3	95% SUBMITTAL	11/28/23	VERDE	WORK ACCEPTED:	INSPECTOR:	DRAWN: MK	DESIGN: VERDE	HOR: AS SHOWN
4	BID SUBMITTAL	1/31/24	VERDE			CHECKED: DM		VERT: AS SHOWN
5	ADDENDUM #6 REVISION: NEW SELF-RETAINING AREAS NEAR PROPERTY LINE 924/24	02/24/24	CITY			APPROVED:	DATE:	JOB NUMBER: 2214701
NO.	DESCRIPTION	DATE	BY	DATE:				
Revisions

GRADING PLAN
BUTTERFIELD PARK PHASE 1
DEVELOPMENT

FILE NUMBER:
PRINT DATE:
SHEET NUMBER: L4.1

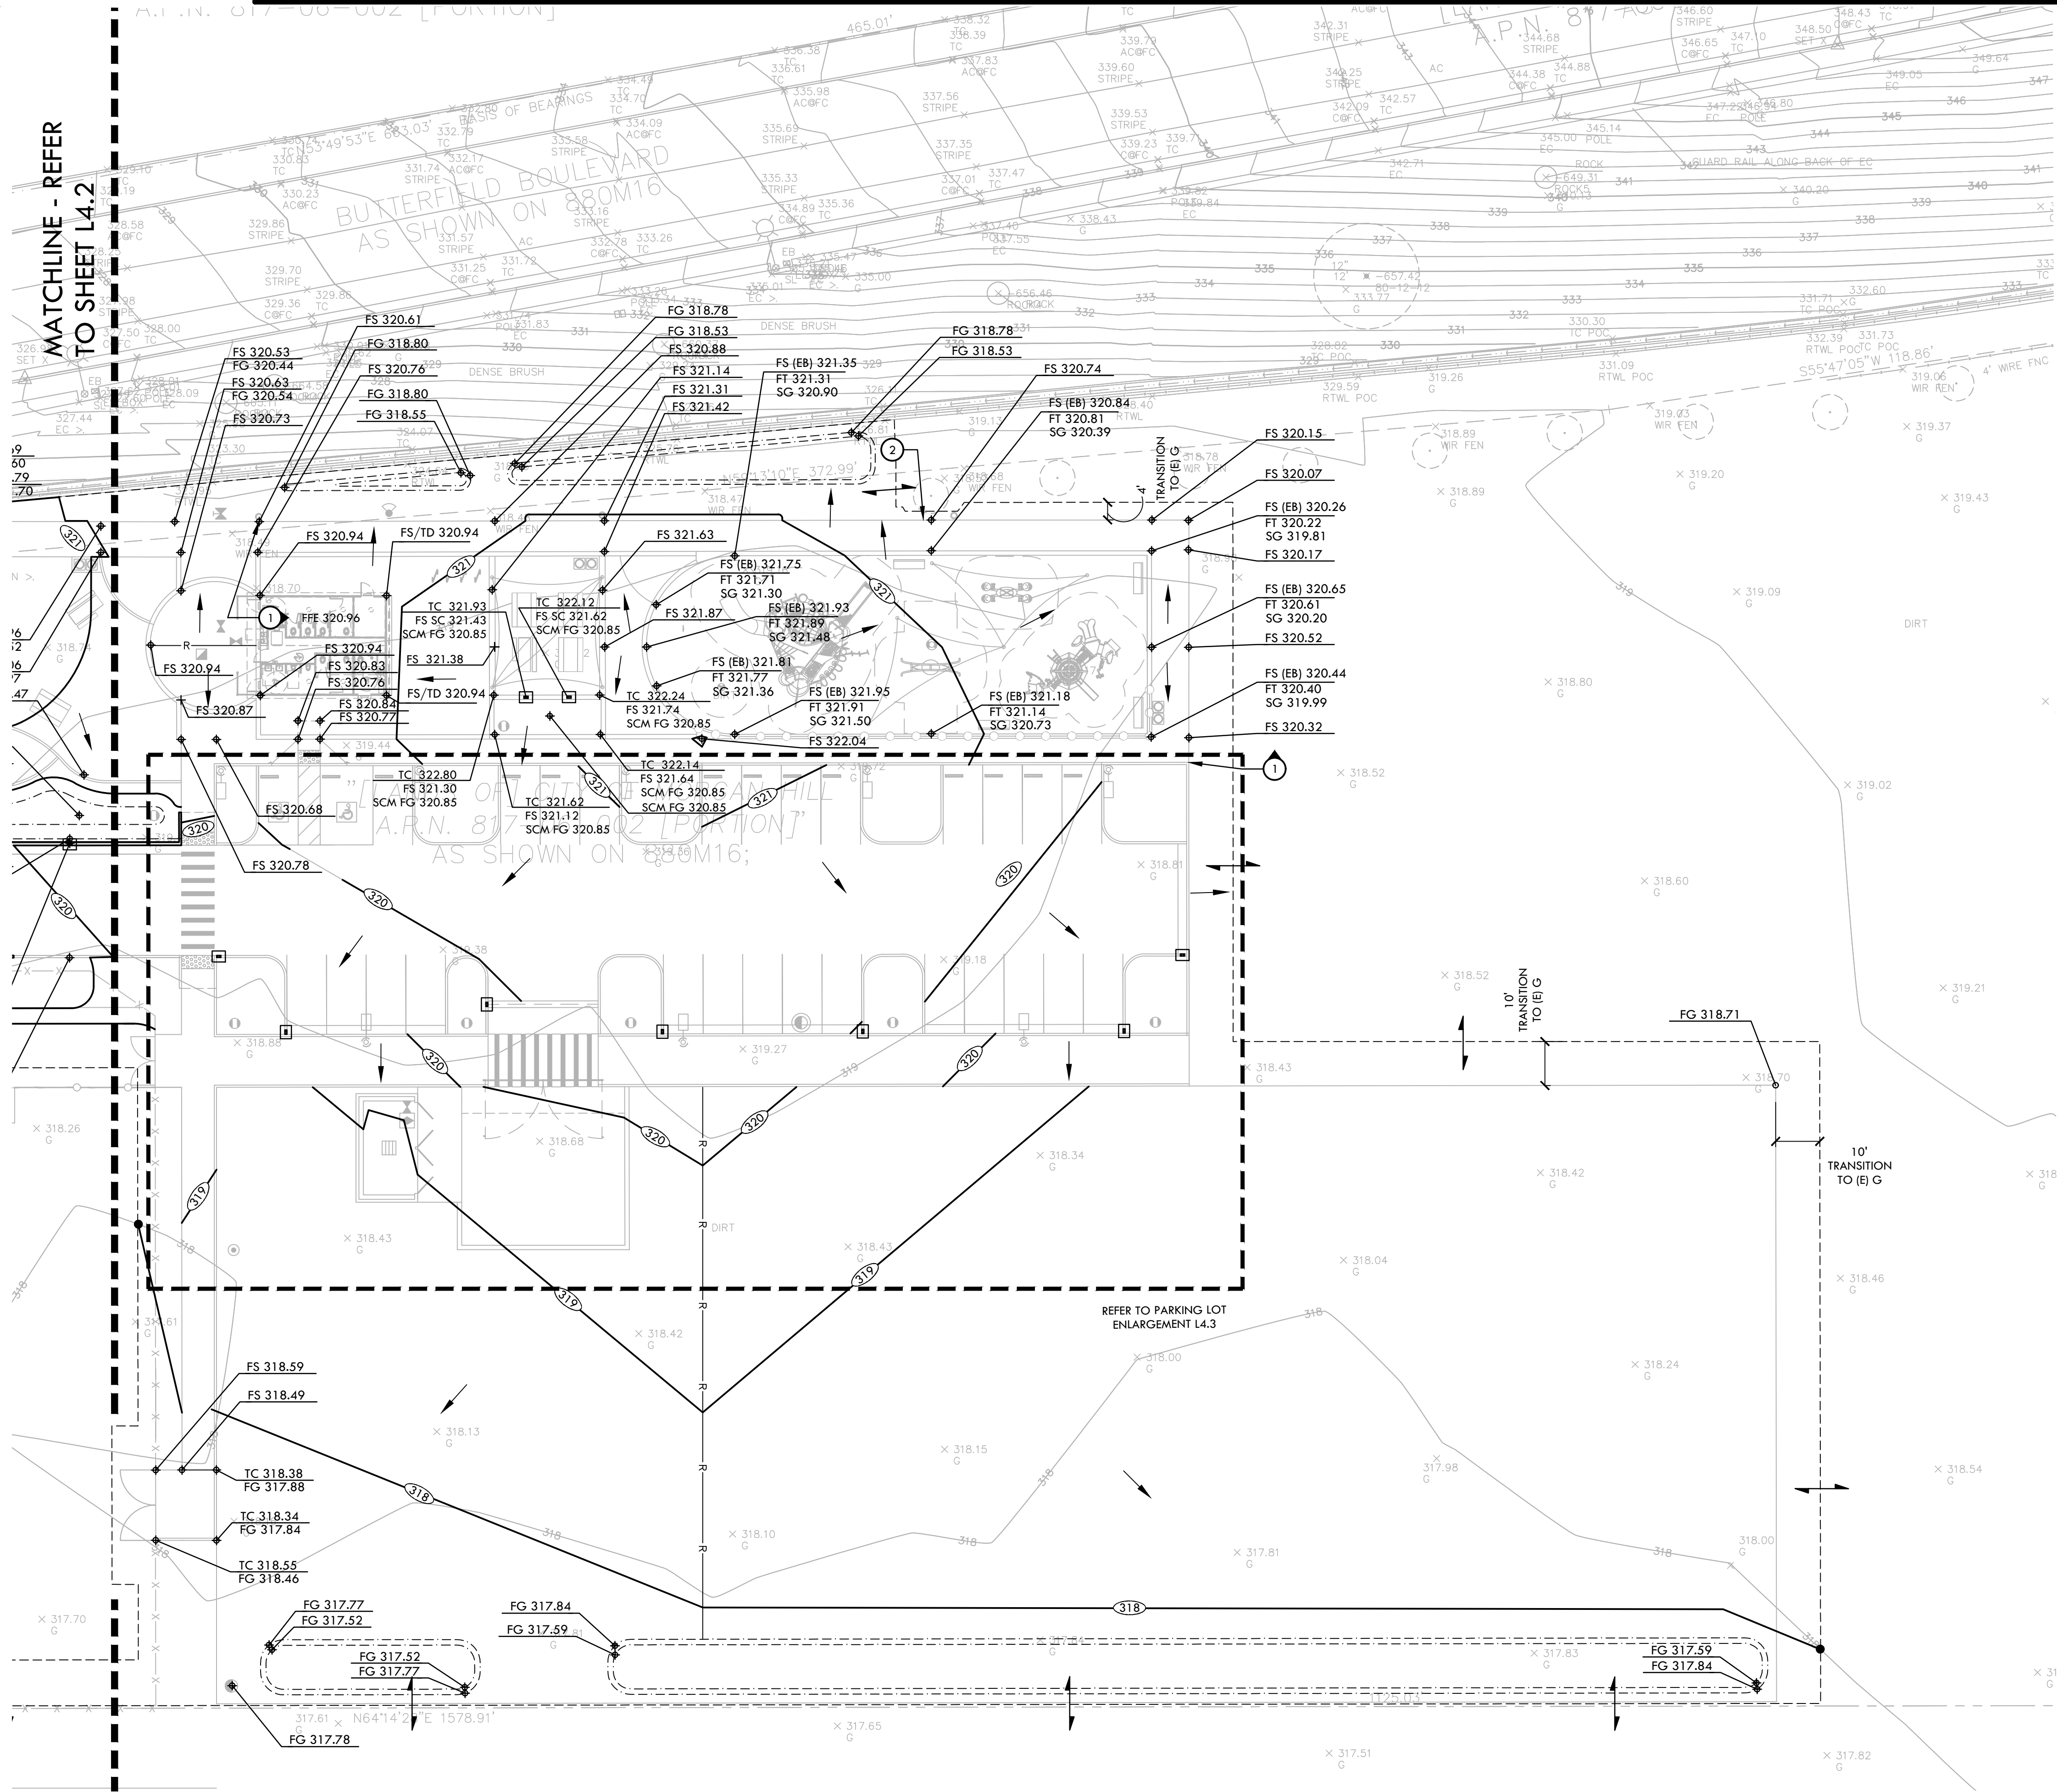
CITY COMMENT REVISIONS 5/17/24
